**BICESTER TO OXFORD TRANSPORT AND WORKS ACT ORDER  
(TWA/10/APP/01) - DISCHARGE OF CONDITION 19 (VIBRATION  
AND NOISE) AS IT RELATES TO SECTION H**

**Annex 1 - Atkins Drawing No 5114534-ATK-DRG-MD-790203 Rev P01**

**Annex 2 - (East West Rail Phase 1: Vibration Assessment for Proposed  
Relocation of Switches and Crossings in Section H)**

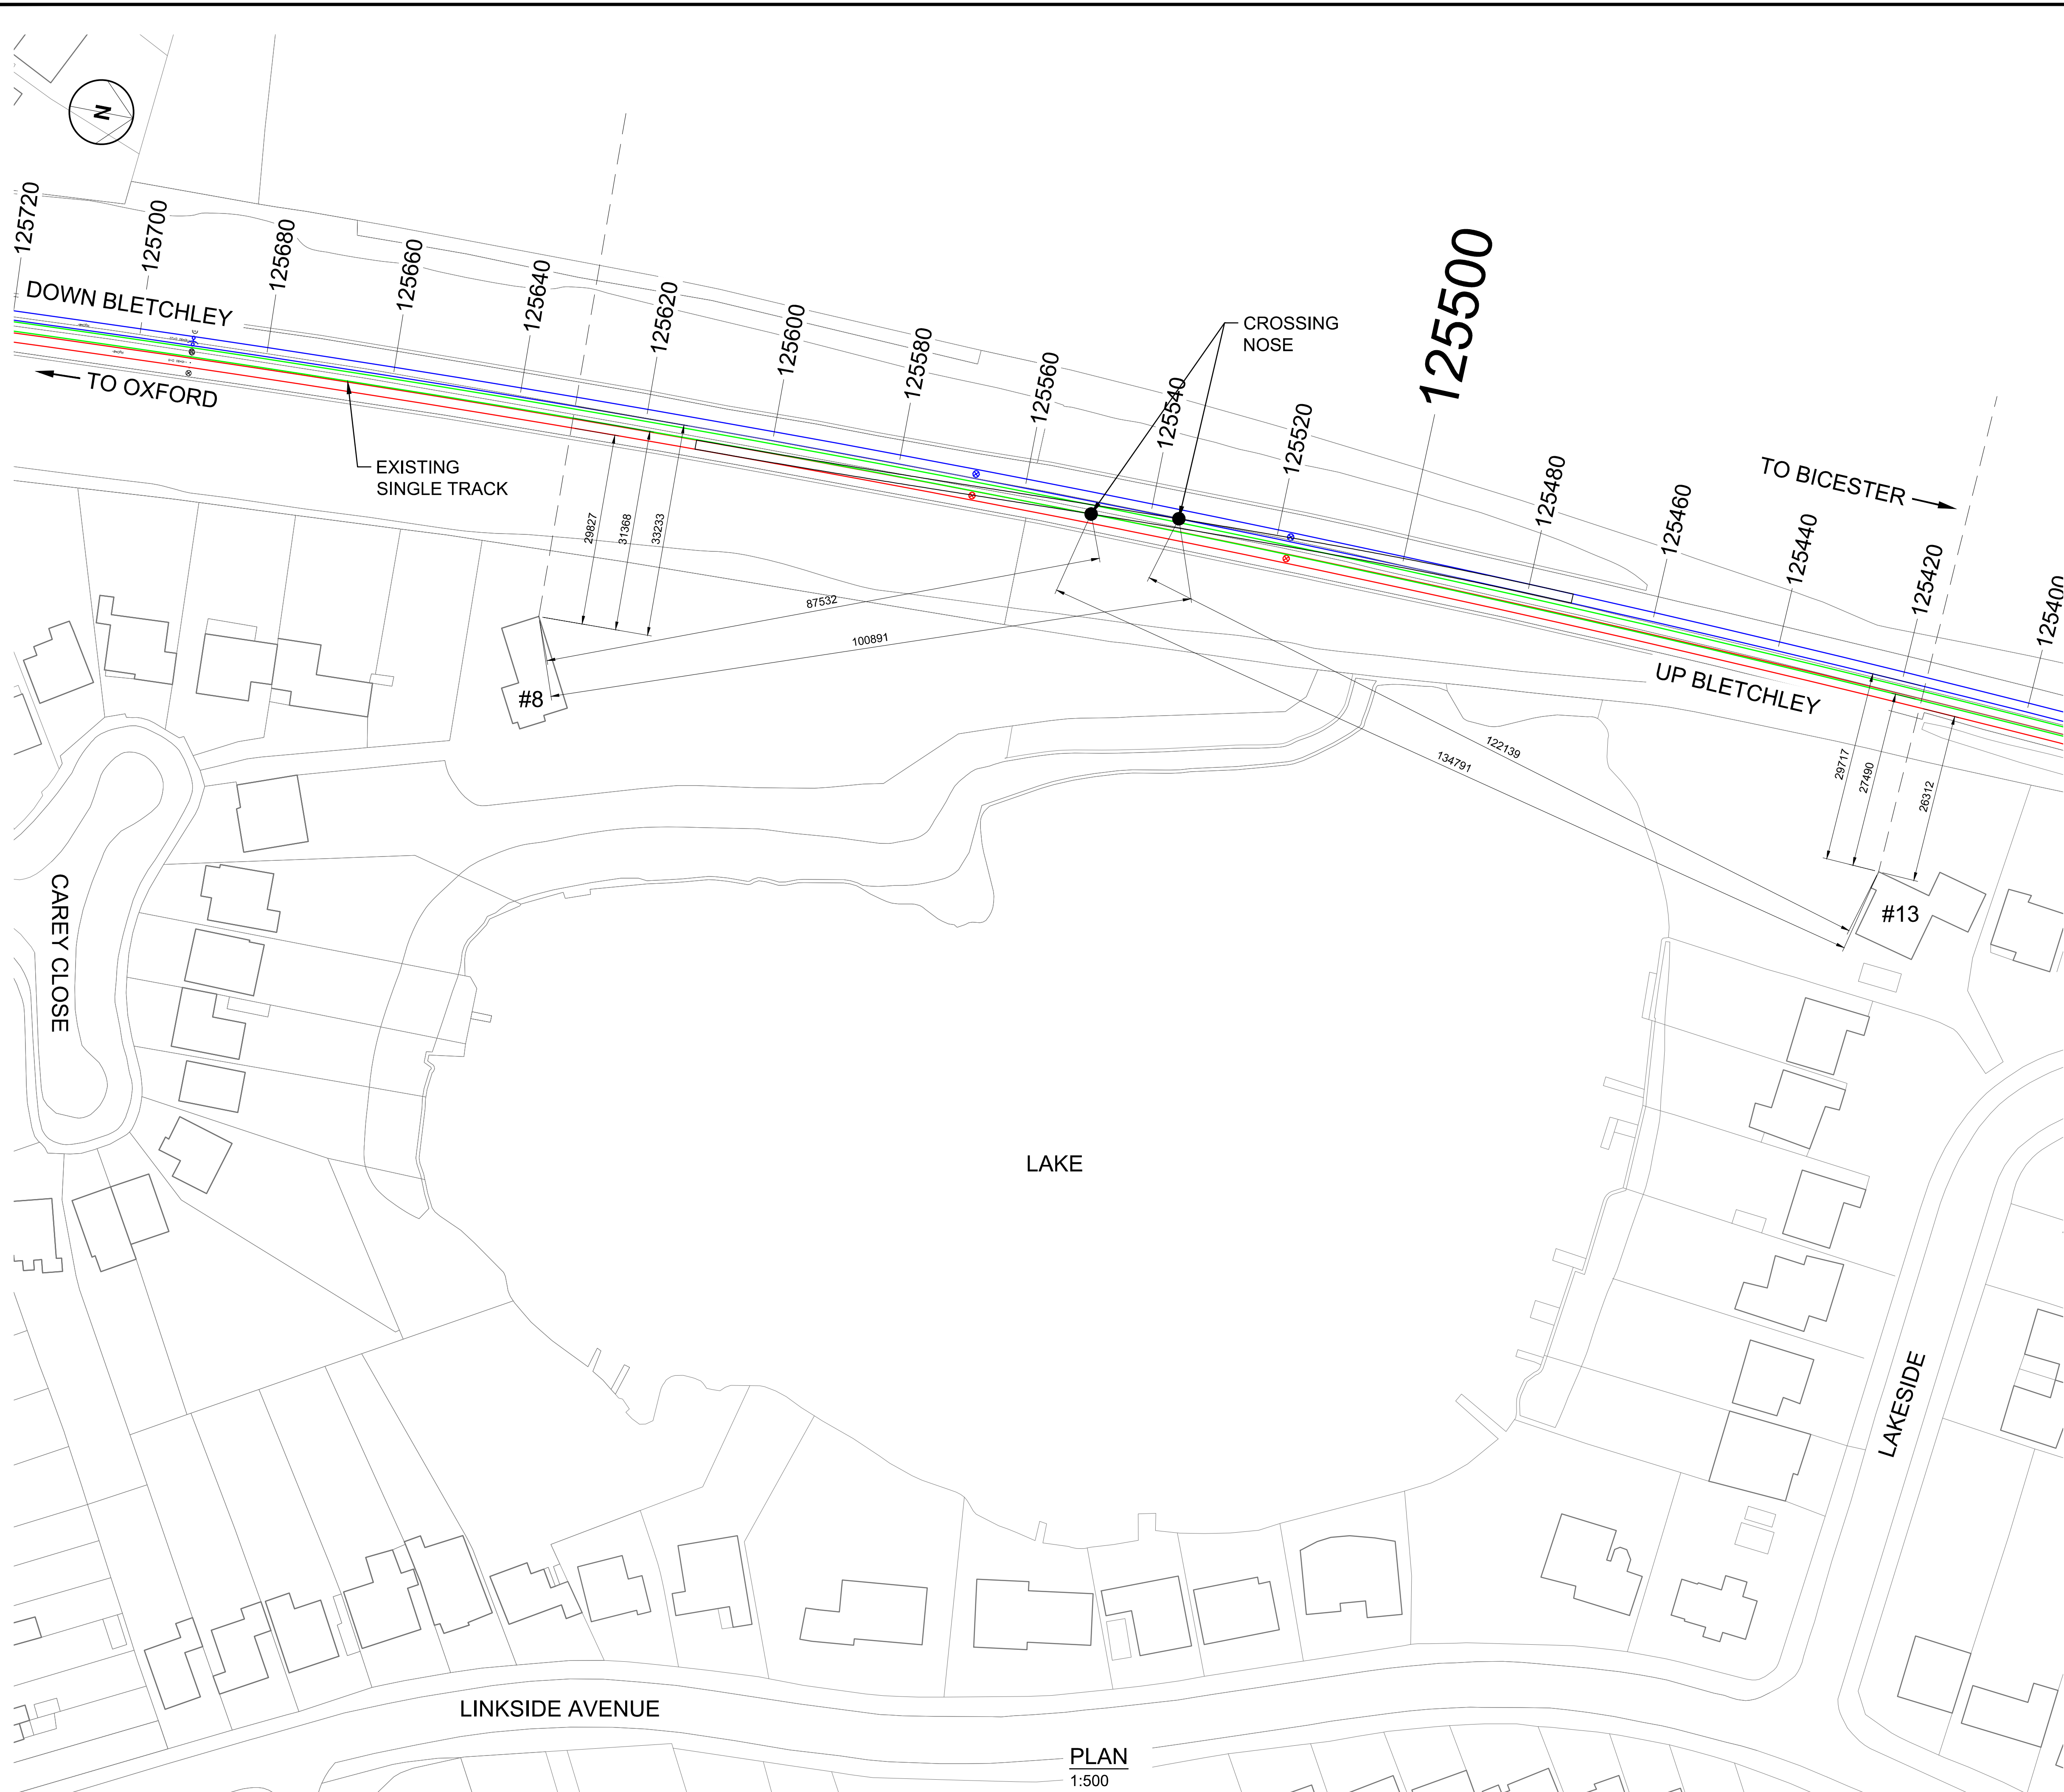
In order to secure approvals of the Vibration SoAs on 19 May, without recourse to speed limits, Network Rail is willing to agree not to install the proposed Switches and Crossing (S&C), which was proposed to be located in the vicinity of 4 Bladon Close (otherwise known as the Woodstock Road Crossover). The effect of this would be to bring the estimated Vibration Dose Values (VDVs) at 4 Bladon Close well within the Scheme limits during both day and night periods.

The Project now proposes to relocate the S&C to a position further north, but still within Section H, at Lakeside. The general layout of the proposed S&C is shown on Atkins drawing no 5114534-ATK-DRG-MD-790203 Rev P01 – chainage 125550, attached here as Annex 1. This location has been chosen in order to be well away from nearby residential (and commercial) properties.

Atkins has undertaken a further vibration assessment for the proposed relocation, attached here in full as Annex 2 (*East West Rail Phase 1: Vibration Assessment for Proposed Relocation of Switches and Crossings in Section H*). This assesses the potential vibration impacts on the nearest property to the S&C, which is identified as 8 Carey Close. This property is located approximately 87.5m and 100m south of the 2 relevant parts of the crossing.

The assessment shows that, based on both the typical transfer functions and the worst-case transfer functions, the estimated VDVs at 8 Carey Close are well within the Scheme vibration threshold limits.

The relocation of the S&C as outlined above will therefore address the potential exceedances at 4 Bladon Close, noted in Andy Milne's letter of 2 April 2015, and will not result in any adverse impacts at the new location, because of the much greater distances from the nearest residential property.
